**SUBJECT****Sunroof Does Not Close****MODEL**

F06 (6 Series Gran Coupe)

F13 (6 Series Coupe)

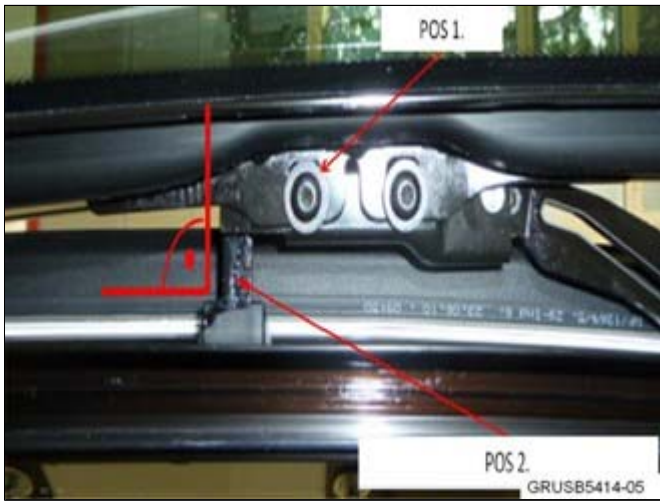
The sunroof seal expands when exposed to the sun and becomes relaxed. This causes the sunroof glass panel to go into “anti-trap” mode during the closing process.

The sunroof glass seal (gasket) must be replaced.

1. Replace the sunroof glass seal with the updated part listed in the “Parts” section below.
2. Refer to Repair Instruction 54 10 120, “Replacing sealing for glass tilt sunroof cover.”
3. During installation of the new seal per Repair Instruction 54 10 120, the following must be performed:
  - The new seal should be installed so that both ends of the seal are positioned midway along the right side of the roof opening (direction of travel).

|  | <ol style="list-style-type: none"> <li>4. During installation of the glass sunroof per Repair Instruction <b>54 10 100</b>, “Removing and installing glass tilt sunroof cover,” the following must be performed.</li> <li>5. When securing the glass sunroof to the mechanism, first secure the front screw on each side (position 1), and then secure the second screw.</li> </ol> |

6. With the glass sunroof panel in the lifted position, check the position of the glass sunroof guide (position 2). This should be positioned as shown. Correct as needed.
